ADDENDUM #2

Reference: Parleys Maintenance Station #234 Improvements
Utah Department of Transportation - Utah
DFCM Project No. 08211900

ADDENDUM NO. 2 to the Contract Documents for the Construction of UDOT Maintenance Station #2434, Parleys Canyon, Utah.

B5 ROOF FRAMING PLAN [PLAN VIEW]

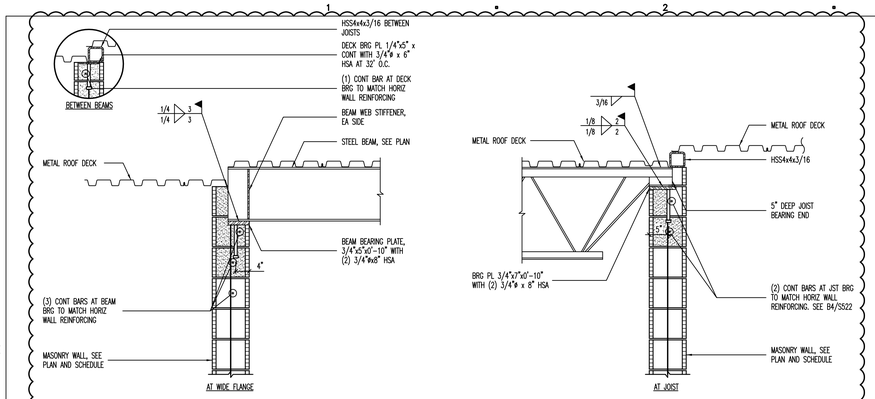
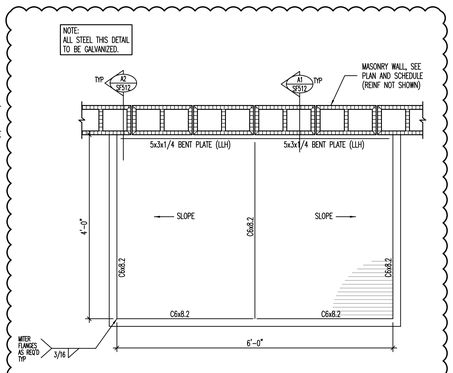
Sheet SF512:

a. Revised detail D1 to reflect offset in deck bearing at oil storage canopy.
b. Revised detail B5 to show canopy slope.

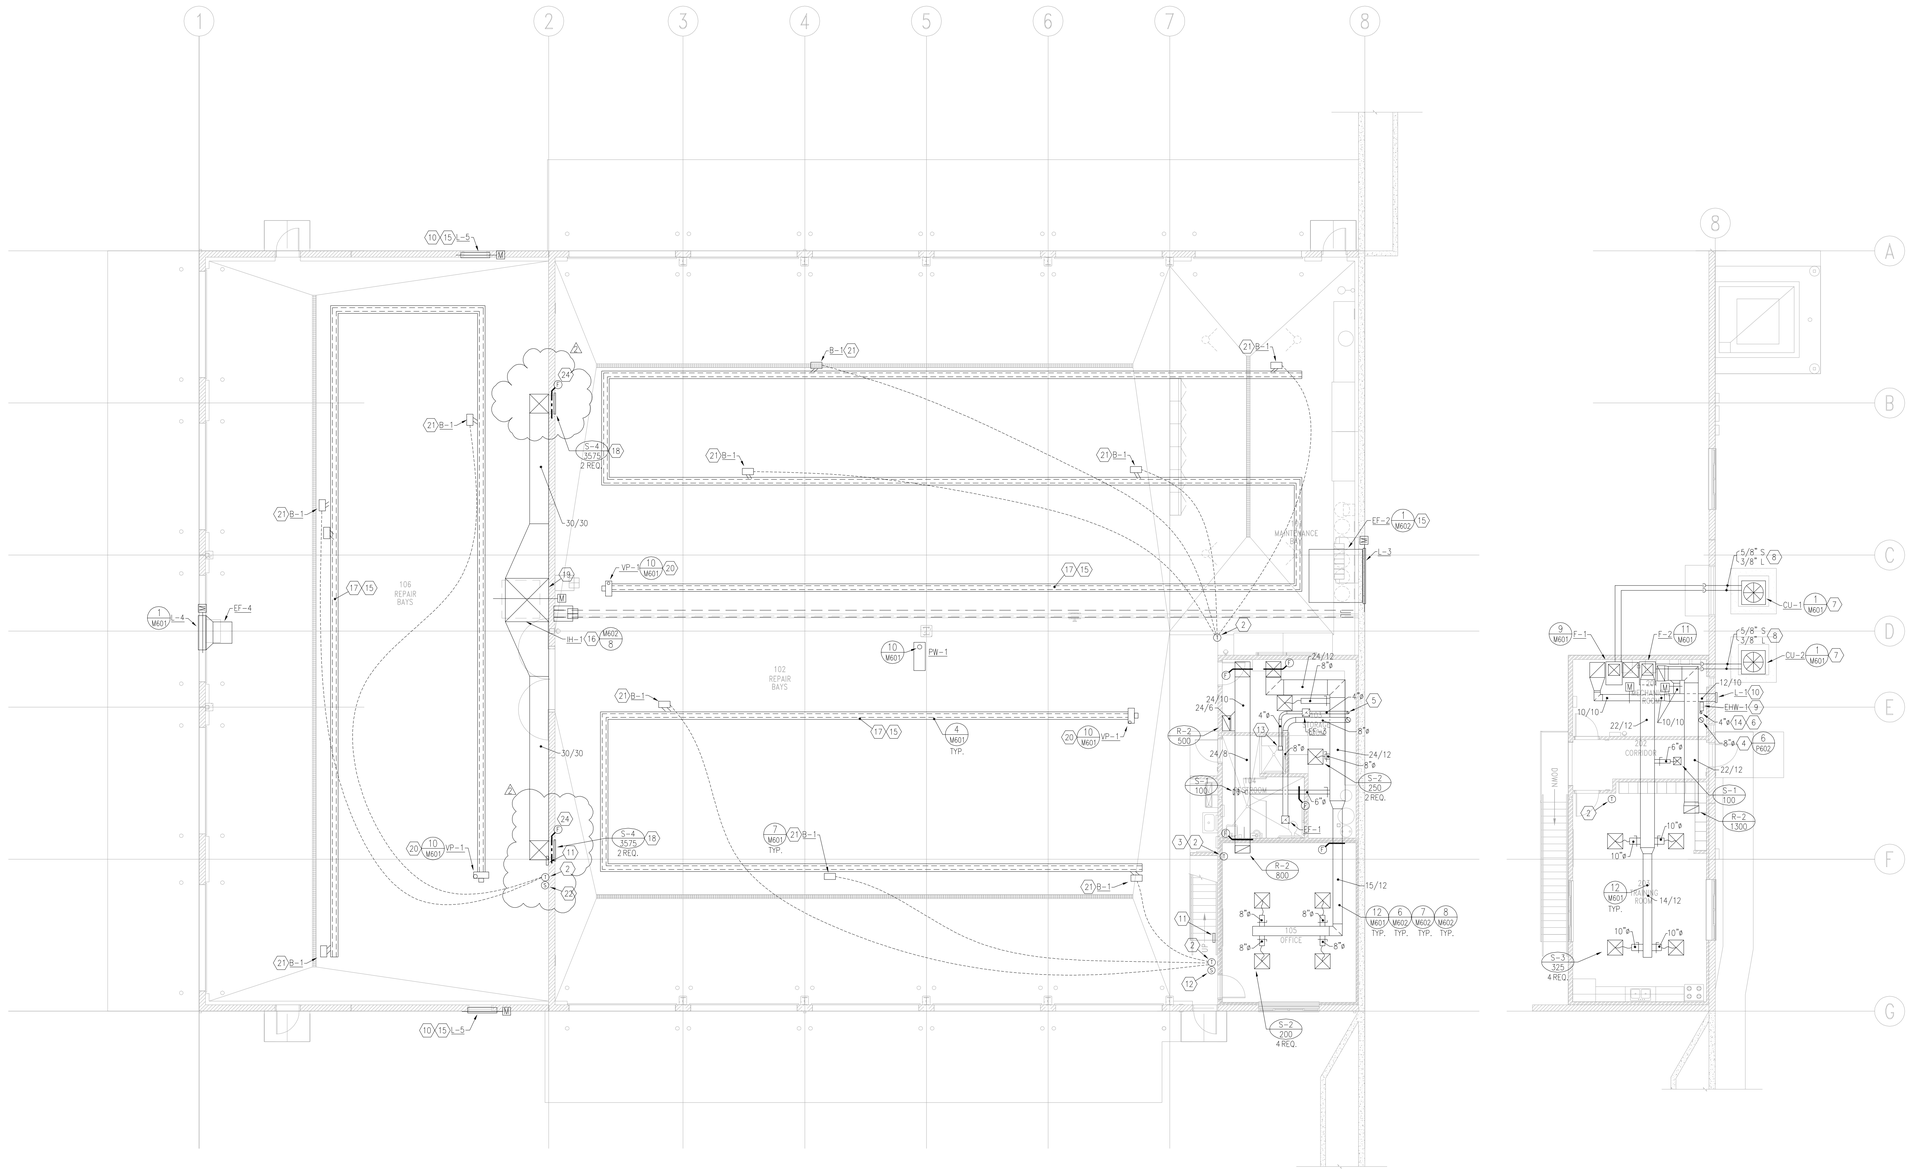
Sheet M201:

a. Revised Damper locations as per Architectural Plan.

ELECTRICAL SITE PLAN

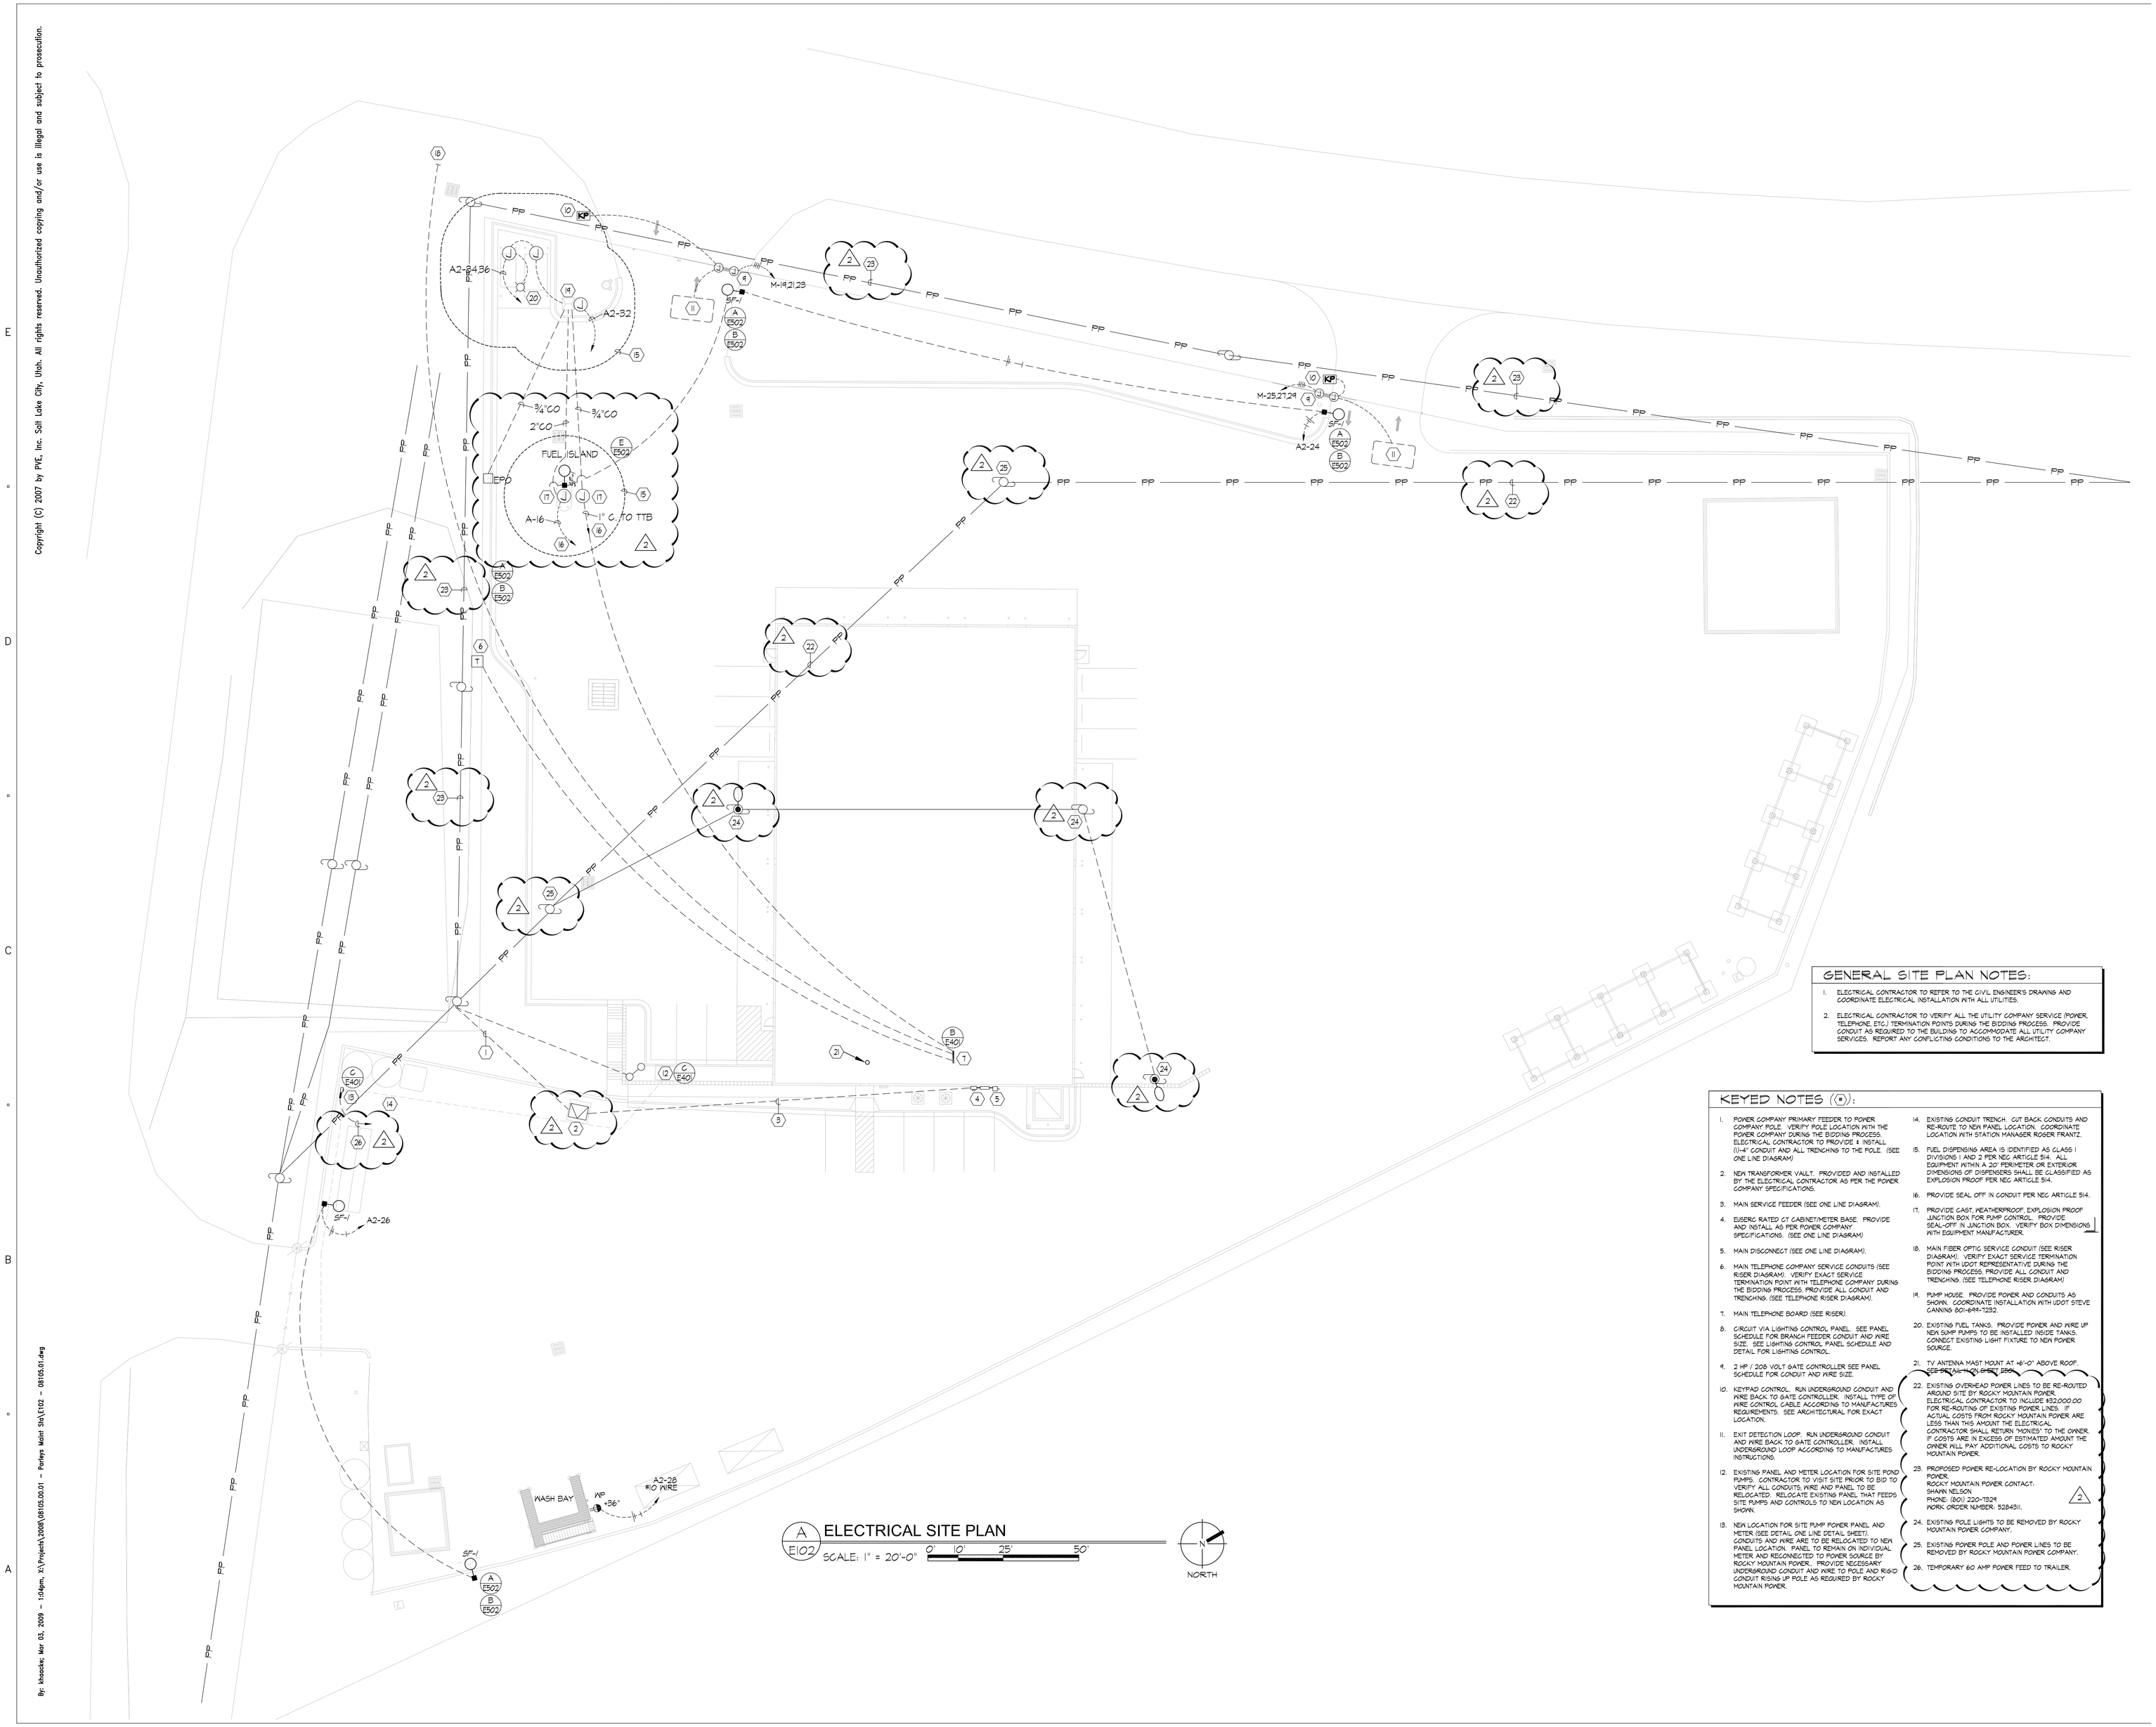
Sheet E102:

a. See Revised Electrical Drawing indicating changes to the electrical service and relocation of existing power lines. Pay special attention to additional sheet notes requiring the electrical contractor to allow a $32,000.00 allowance for the relocation of the existing overhead electrical lines.
